STAFF REPORT: JUNE 8, 2022 MEETING

APPLICATION NUMBER: 22-7847

ADDRESS: 2235 LONGFELLOW

SCOPE: REPLACE ASPHALT SHINGLES ON DORMERS WITH VINYL PRODUCT

Staff photo of existing conditions of front entry

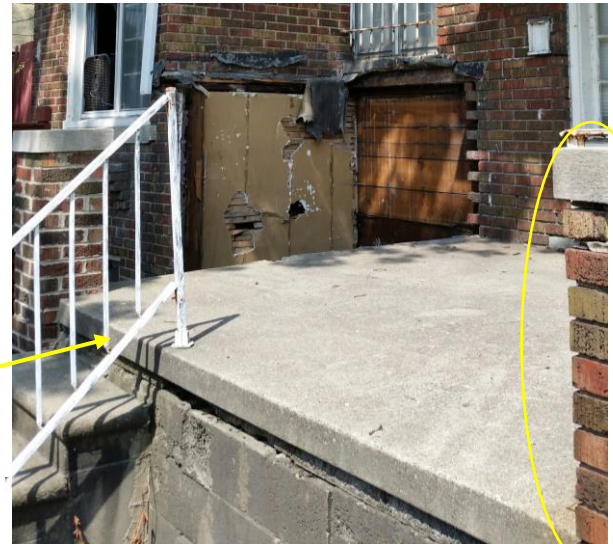
- The existing portico columns are not original to the house. Ionic fluted double columns, as seen in the 1974 (below left) and 1980 (below right) HDAB photos were removed at an unknown time. The square, trimmed out columns, painted to match the existing trim, were erected as part of the 2017 rehabilitation and included within the Certificate of Appropriateness (#17-5345).
